Product Change Notice (PCN)

Subject: Addition of production sites for RL78/G11(16pin), G1P, I1D, G1A.

**Difference of specification
(RL78 family HWQFN products)
3mm×3mm 0.5mm pitch 16pin
4mm×4mm 0.5mm pitch 24pin
5mm×5mm 0.5mm pitch 32pin**

MCP-AB-22-0089

3mm×3mm 0.5mm pitch 16pin HWQFN Package outline (Greatek)

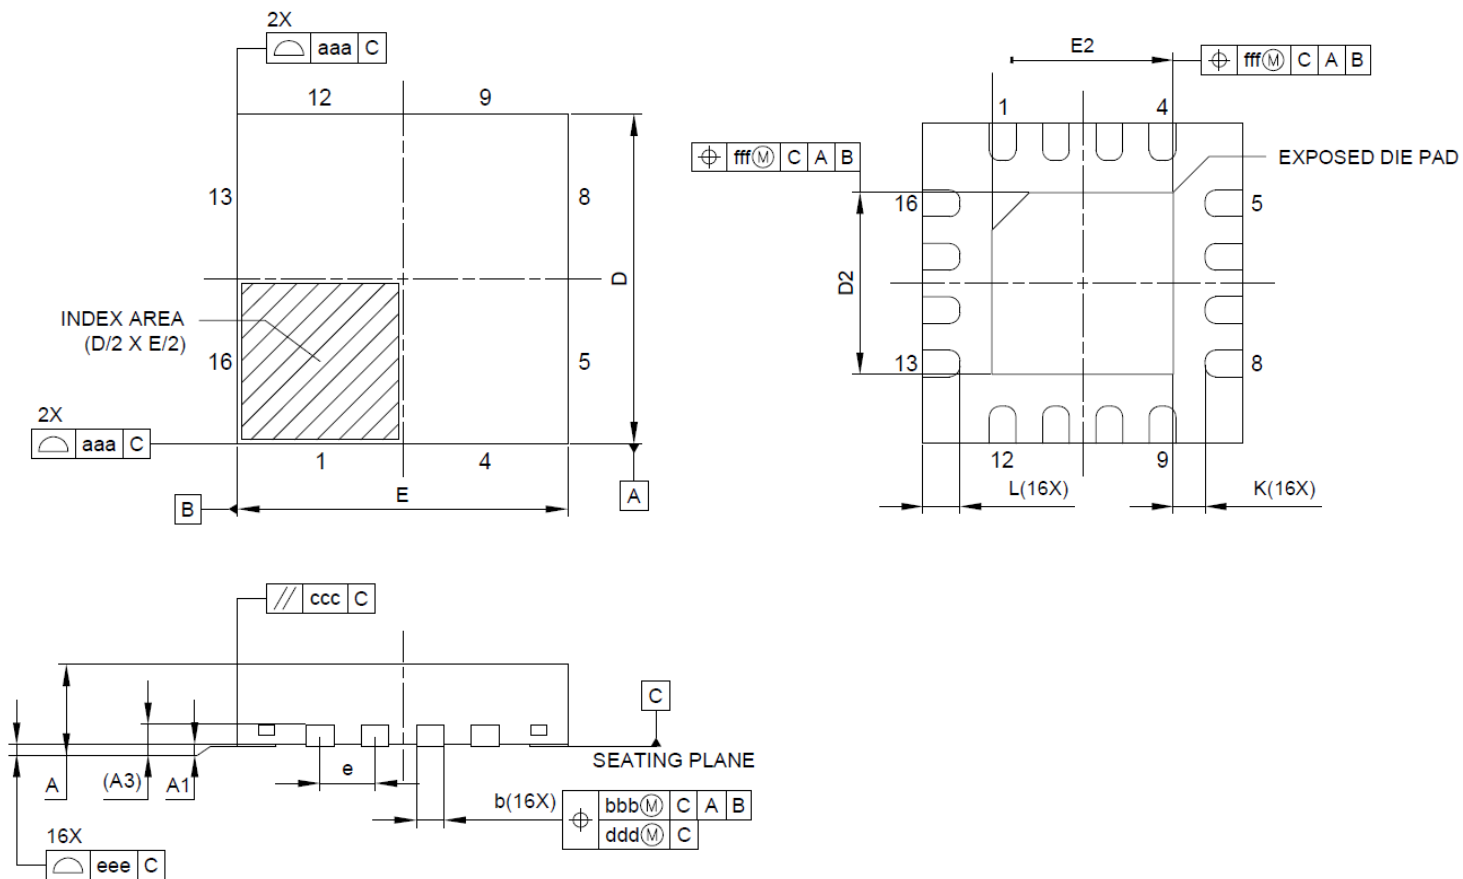
Dimension comparison: 3mm×3mm 0.5mm pitch 16pin HWQFN

UTAC Symbol	3x3mm 16pin HWQFN PWQN0016KE-A			Greatek Symbol	3x3mm 16pin HWQFN PWQN0016KD-A		
	Dimension in Millimeters				Dimension in Millimeters		
	Min	Nom	Max		Min	Nom	Max
A	-	-	0.80	A	-	-	0.80
A1	0.00	-	0.05	A1	0.00	0.02	0.05
A3	0.20 REF.			A3	0.203 REF.		
b	0.20	0.25	0.30	b	0.20	0.25	0.30
D	-	3.00	-	D	3.00 BSC		
E	-	3.00	-	E	3.00 BSC		
e	-	0.50	-	e	0.50 BSC		
N	16			-	-	-	-
L	0.25	0.35	0.45	L	0.30	0.35	0.40
K	0.20	-	-	K	0.20	-	-
D2	1.60	1.70	1.80	D2	1.65	1.70	1.75
E2	1.60	1.70	1.80	E2	1.65	1.70	1.75
aaa	-	-	0.15	aaa	0.15		
bbb	-	-	0.10	bbb	0.10		
ccc	-	-	0.10	ccc	0.10		
ddd	-	-	0.05	ddd	0.05		
eee	-	-	0.08	eee	0.08		
-	-	-	-	fff	0.10

4mm×4mm 0.5mm pitch 24pin HWQFN Package outline (UTAC)

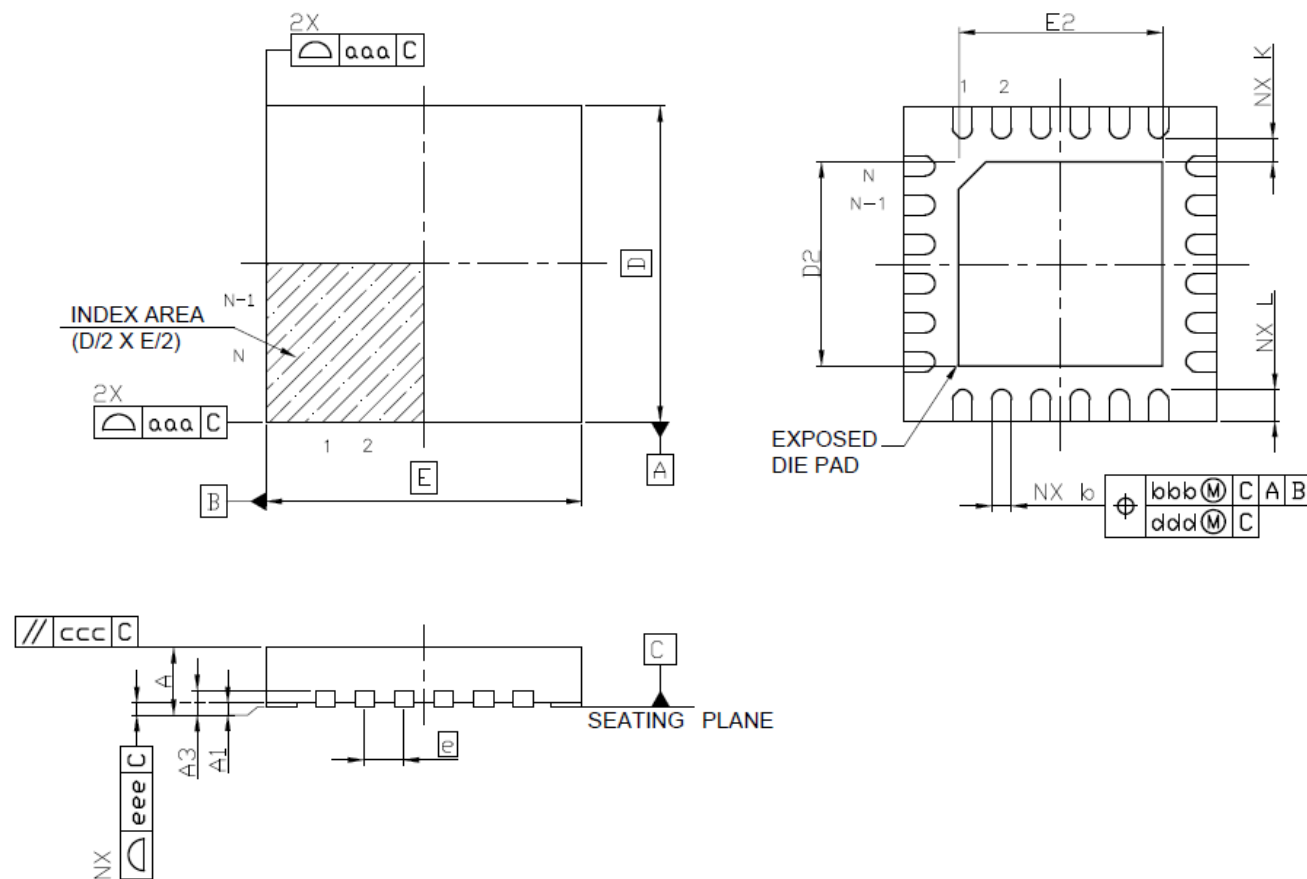
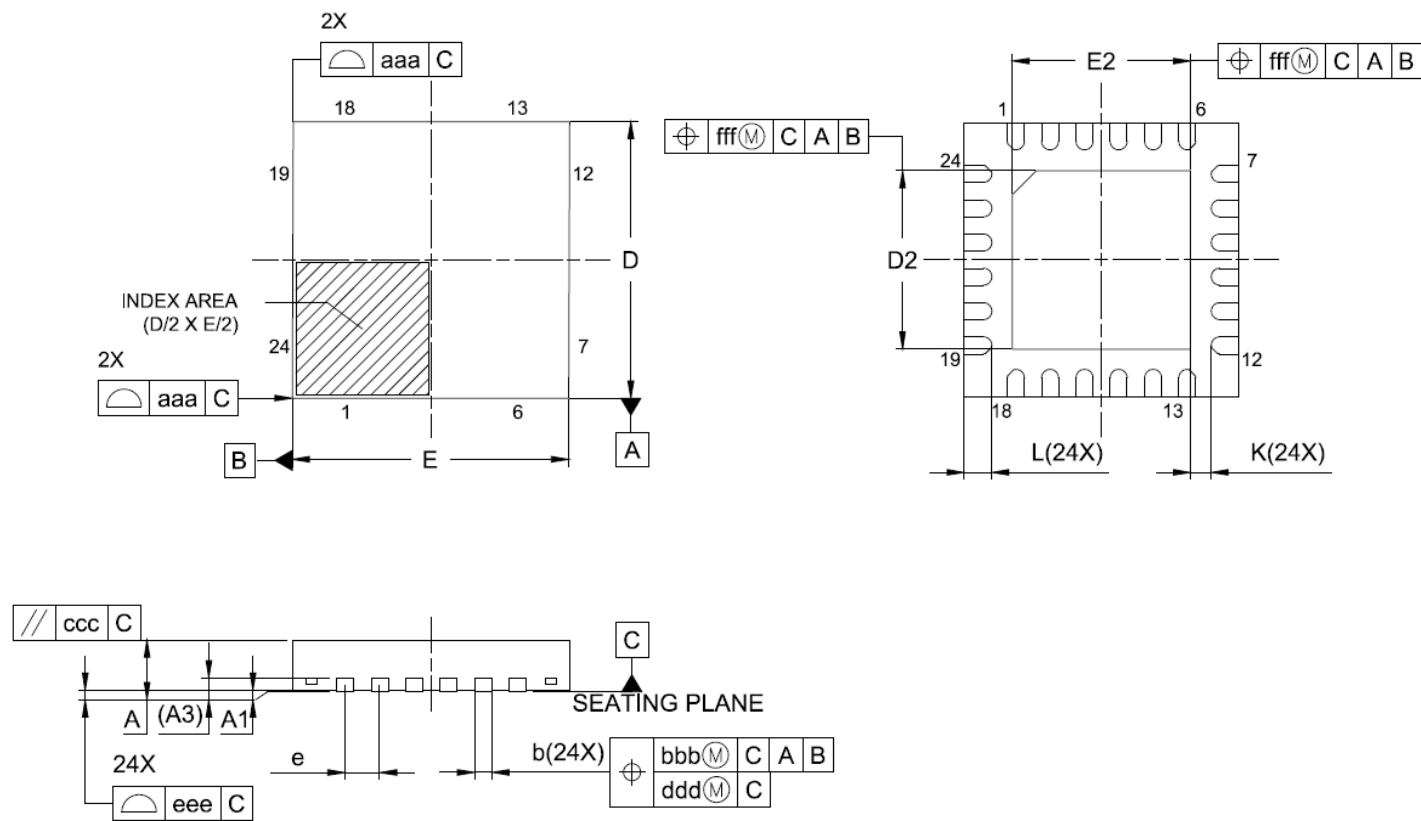
Dimension comparison: 4mm×4mm 0.5mm pitch 24pin HWQFN

UTAC Symbol	4x4mm 24pin HWQFN PWQN0024KH-A			Greatek Symbol	4x4mm 24pin HWQFN PWQN0024KF-A		
	Dimension in Millimeters				Dimension in Millimeters		
	Min	Nom	Max		Min	Nom	Max
A	-	-	0.80	A	-	-	0.80
A1	0.00	-	0.05	A1	0.00	0.02	0.05
A3	0.20 REF.			A3	0.203 REF.		
b	0.20	0.25	0.30	b	0.18	0.25	0.30
D	-	4.00	-	D	4.00 BSC		
E	-	4.00	-	E	4.00 BSC		
e	-	0.50	-	e	0.50 BSC		
N	24			-	-	-	-
L	0.30	0.40	0.50	L	0.35	0.40	0.45
K	0.20	-	-	K	0.20	-	-
D2	2.50	2.60	2.70	D2	2.55	2.60	2.65
E2	2.50	2.60	2.70	E2	2.55	2.60	2.65
aaa	-	-	0.15	aaa	0.15		
bbb	-	-	0.10	bbb	0.10		
ccc	-	-	0.10	ccc	0.10		
ddd	-	-	0.05	ddd	0.05		
eee	-	-	0.08	eee	0.08		
-	-	-	-	fff	0.10

5mm×5mm 0.5mm pitch 32pin HWQFN Package outline (UTAC)

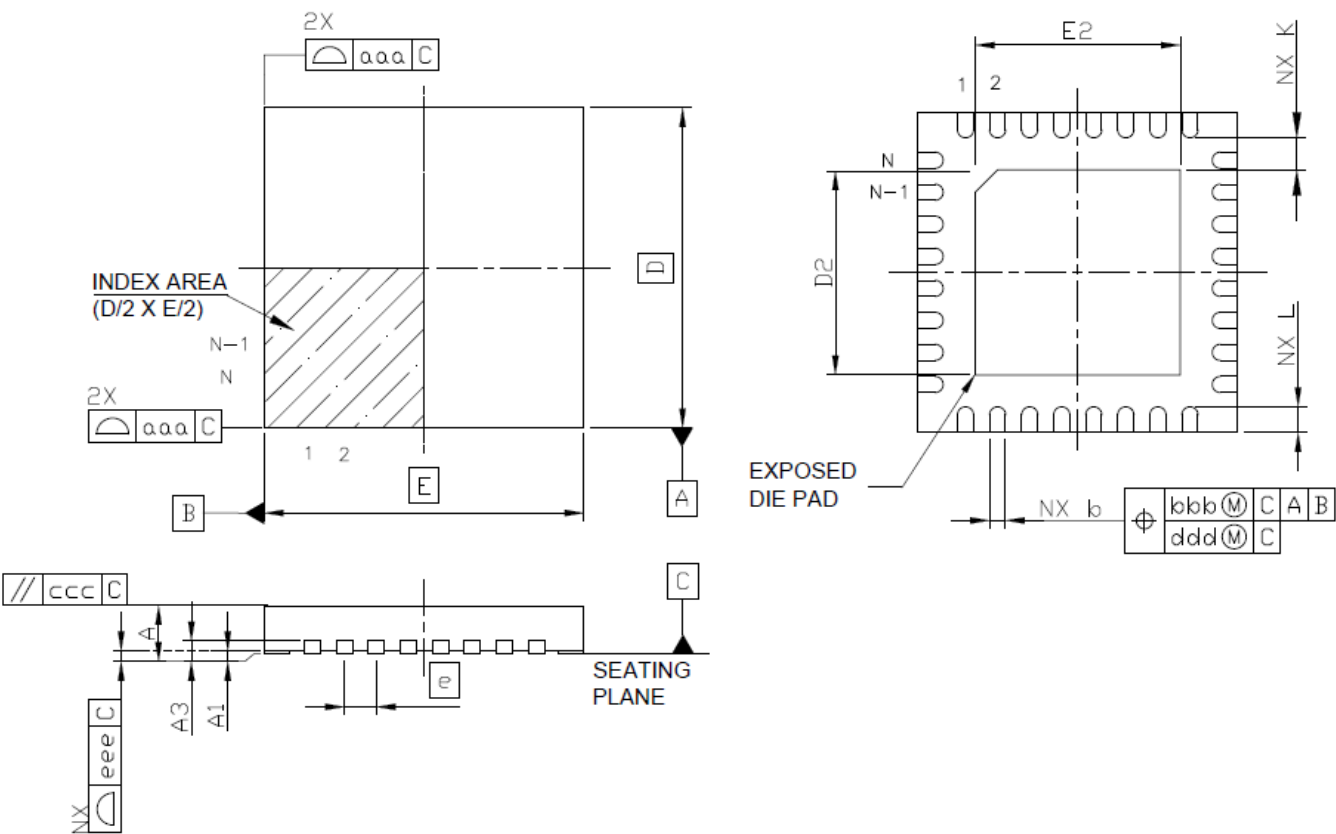
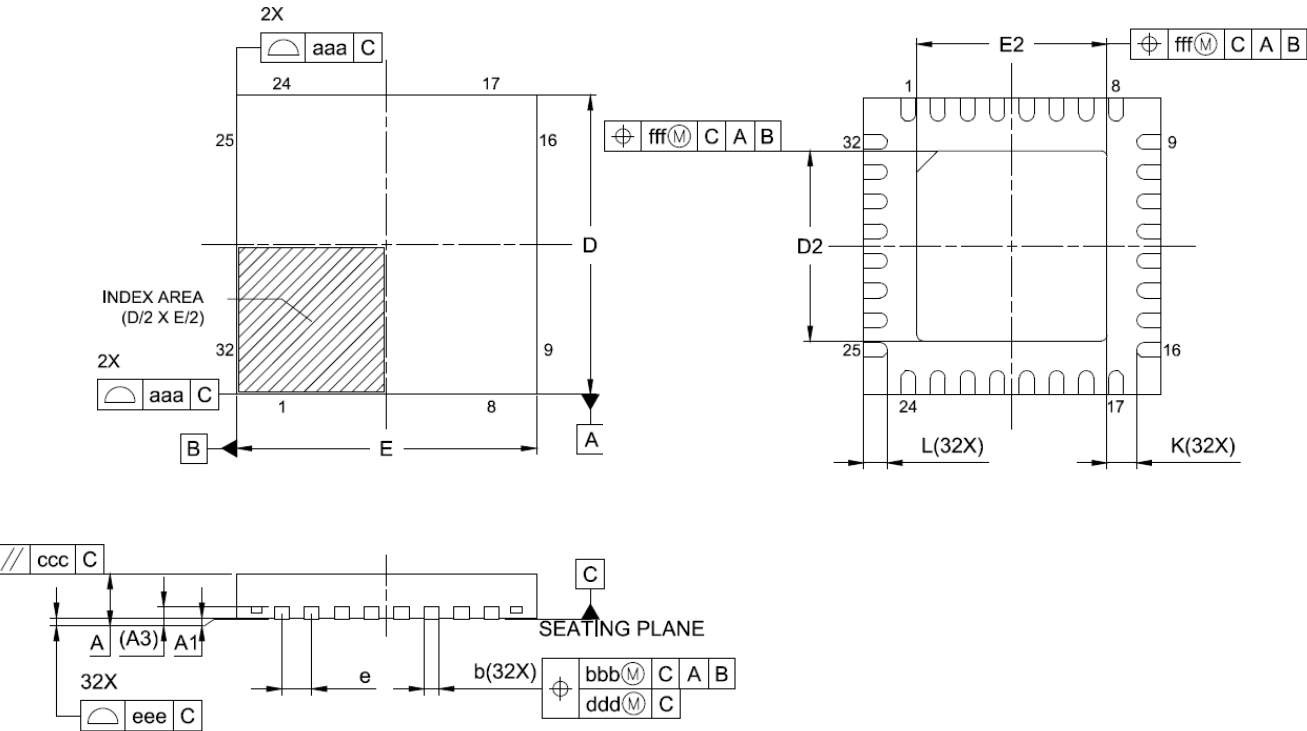
Dimension comparison: 5mm×5mm 0.5mm pitch 32pin HWQFN

UTAC Symbol	5x5mm 32pin HWQFN PWQN0032KG-A			Greatek Symbol	5x5mm 32pin HWQFN PWQN0032KE-A		
	Dimension in Millimeters				Dimension in Millimeters		
	Min	Nom	Max		Min	Nom	Max
A	-	-	0.80	A	-	-	0.80
A1	0.00	-	0.05	A1	0.00	0.02	0.05
A3	0.20 REF.			A3	0.203 REF.		
B	0.20	0.25	0.30	b	0.18	0.25	0.30
D	-	5.00	-	D	5.00 BSC		
E	-	5.00	-	E	5.00 BSC		
e	-	0.50	-	e	0.50 BSC		
N	32			N	-	-	-
L	0.30	0.40	0.50	L	0.35	0.40	0.45
K	0.20	-	-	K	0.20	-	-
D2	3.10	3.20	3.30	D2	3.15	3.20	3.25
E2	3.10	3.20	3.30	E2	3.15	3.20	3.25
aaa	-	-	0.15	aaa	0.15		
bbb	-	-	0.10	bbb	0.10		
ccc	-	-	0.10	ccc	0.10		
ddd	-	-	0.05	ddd	0.05		
eee	-	-	0.08	eee	0.08		
-	-	-	-	fff	0.10

Package structure image

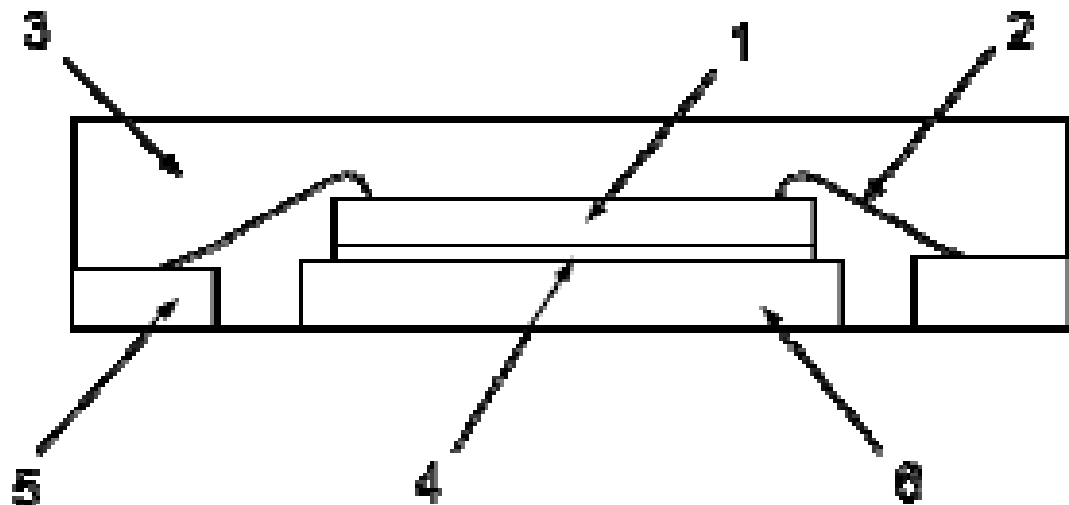
* Different materials will be used at UTAC but their structure is same as those conventionally used.

Marking visibility

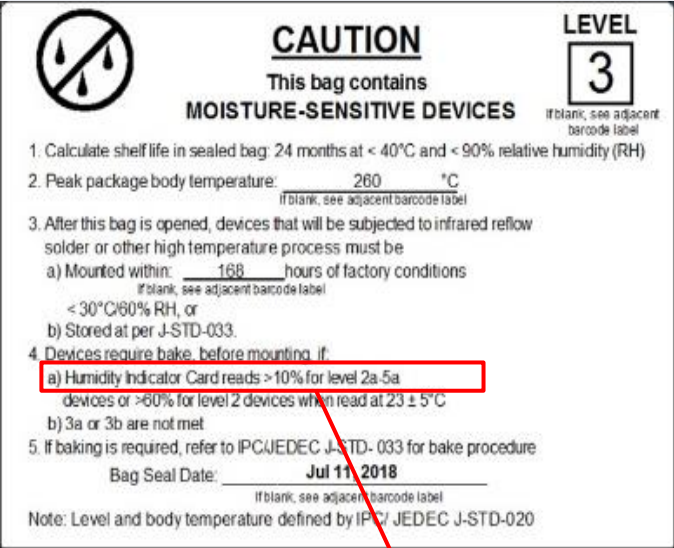
6) Marking

Change the marking font.

Packing specification for Tray

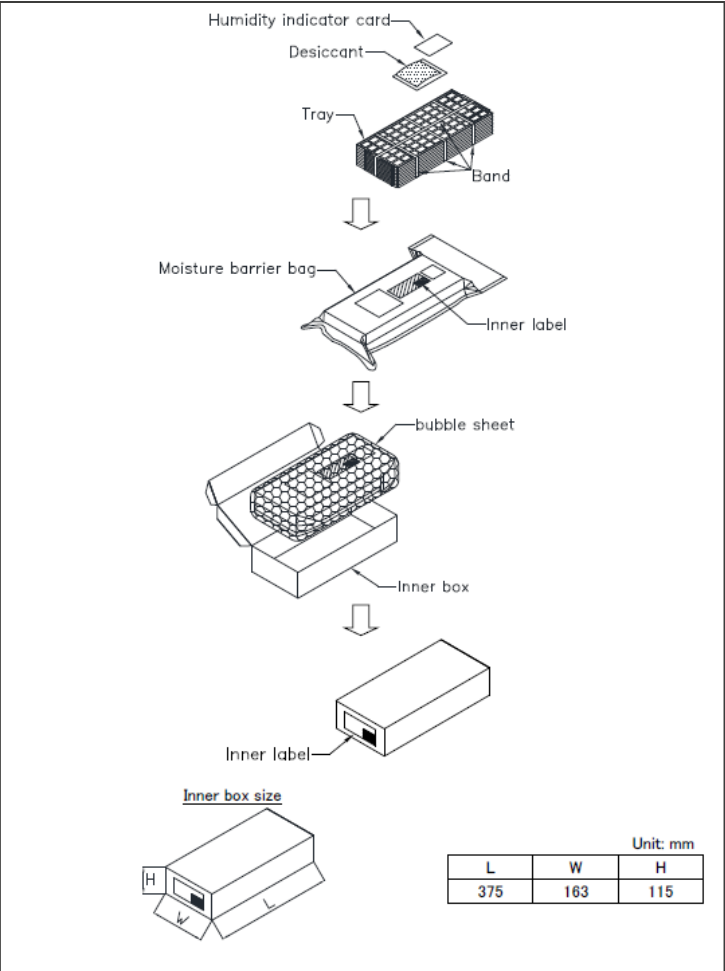
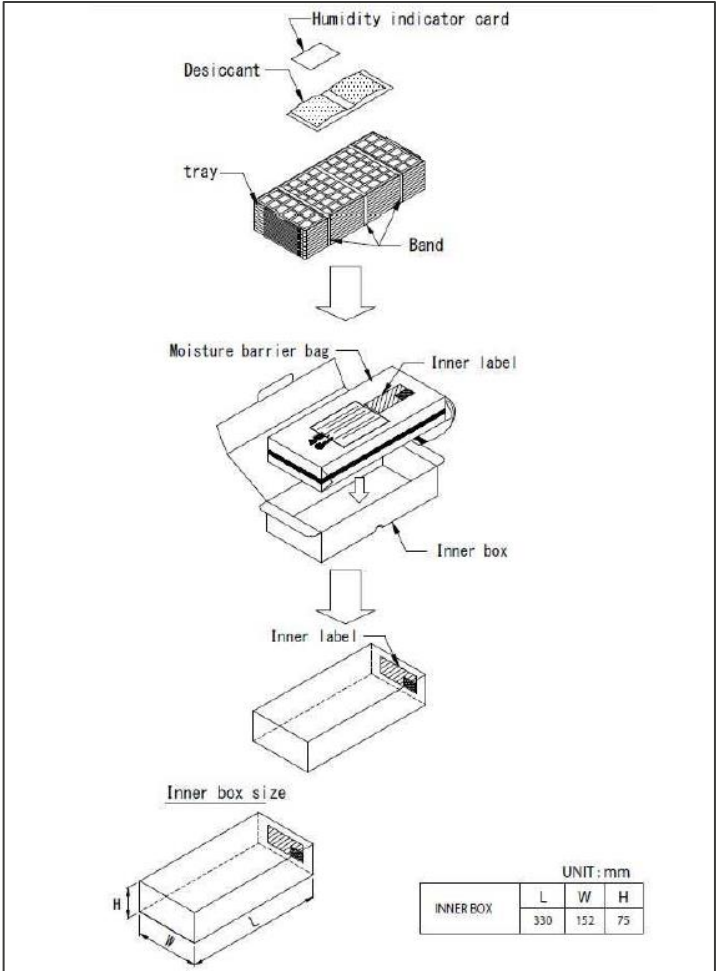
Packing material	Tray	
	Additional (UTAC)	Existing (KYEC)
Number of trays contained in the inner box	•Tray : 8 trays+ 1 cover 	•Tray : 8 trays+ 1 cover 
Band	•Band : 4 (3 on the short side + 1 on the long side)	•Band : 3 (3 on the short side)
Desiccant	•Weight : 33g 	•Weight : 25g+25g

Packing material	Tray	
	Additional (UTAC)	Existing (KYEC)
Moisture barrier bag	•Size : 228.6mm×508mm Caution label Inner label 	•Size : 250mm×510mm Inner label 
Inner box	•Size : 163mm×375mm×115mm Bubble sheet Inner Box Filament tape Inner label 	•Size : 152mm×330mm×75mm  Inner Box  Inner label

Dimension comparison: 3mm×3mm 16pin HWQFN Emboss tape

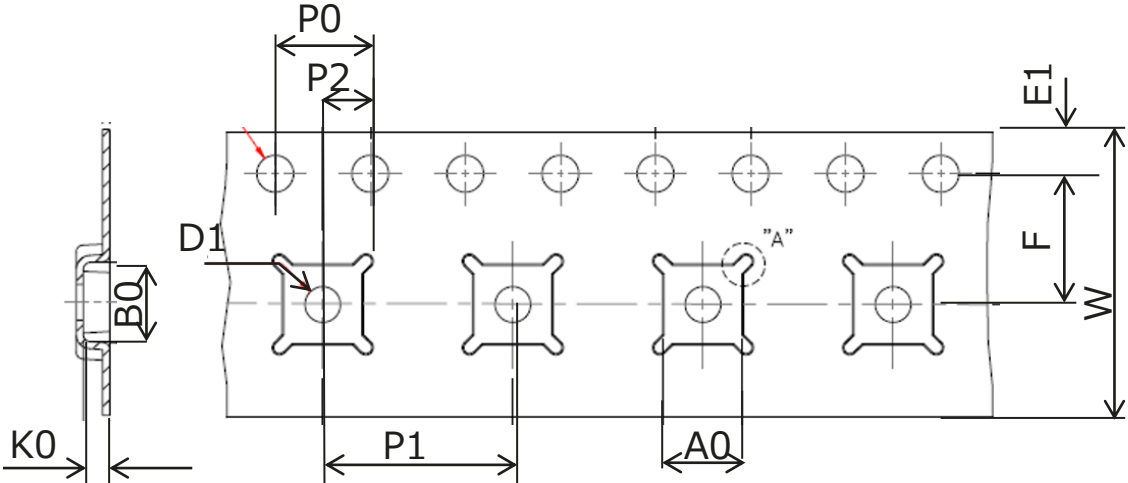
Symbol	Additional (UTAC)	Existing (KYEK)
A0	3.30	3.30
B0	3.30	3.30
K0	1.10	1.10
P1	8.00	8.00
W	12.00	12.00
E1	1.75	1.75
P0	4.00	4.00
F	5.50	5.50
P2	2.00	2.00
D1	Φ1.50MIN	Φ1.60

Dimension comparison: 4mm×4mm 24pin HWQFN Emboss tape

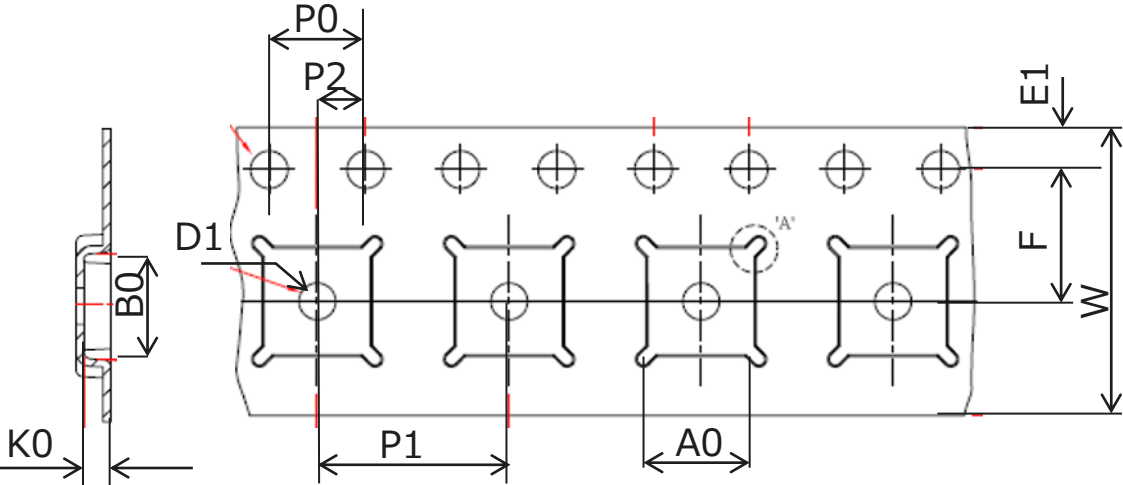
Symbol	Additional (UTAC)	Existing (KYECC)
A0	4.30	4.25
B0	4.30	4.25
K0	1.10	1.10
P1	8.00	8.00
W	12.00	12.00
E1	1.75	1.75
P0	4.00	4.00
F	5.50	5.50
P2	2.00	2.00
D1	Φ1.50MIN	Φ1.60

Dimension comparison: 5mm×5mm 32pin HWQFN Emboss tape

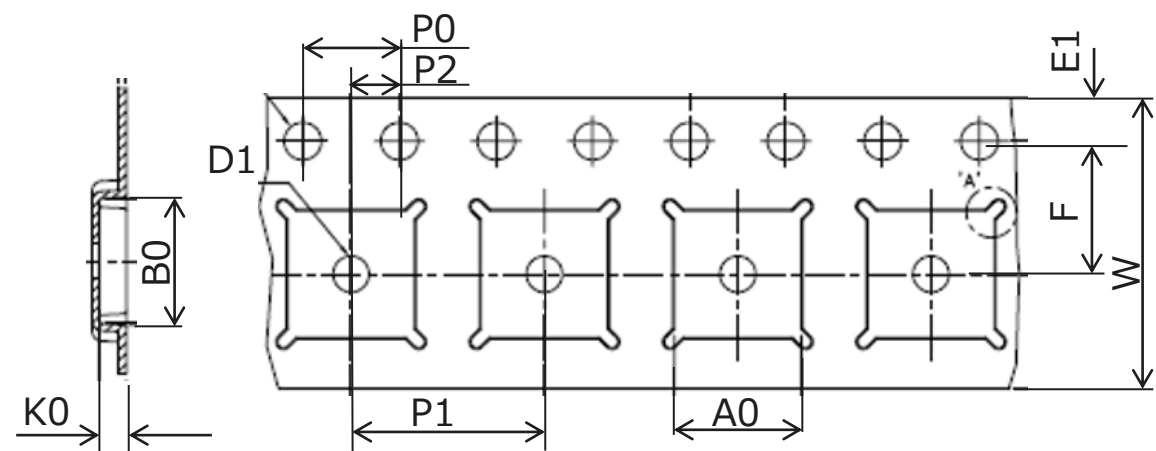
Symbol	Additional (UTAC)	Existing (KYECC)
A0	5.25	5.30
B0	5.25	5.30
K0	1.10	1.10
P1	8.00	8.00
W	12.00	12.00
E1	1.75	1.75
P0	4.00	4.00
F	5.50	5.50
P2	2.00	2.00
D1	Φ1.50MIN	Φ1.60

Dimension comparison: Reel (HWQFN common)

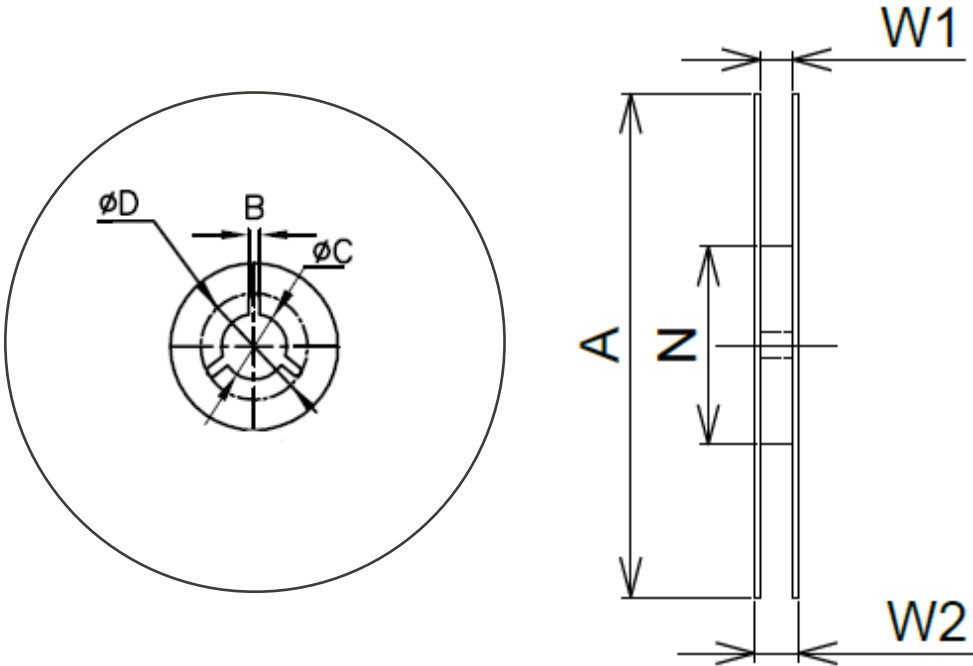
Symbol	Additional (UTAC)	Existing (KYEK)
B	1.5	2.0
ϕC	13.0	13.0
ϕD	20.2	21.0
A	330	330
N	100	102
W1	12.4	12.8
W2	18.4	18.4
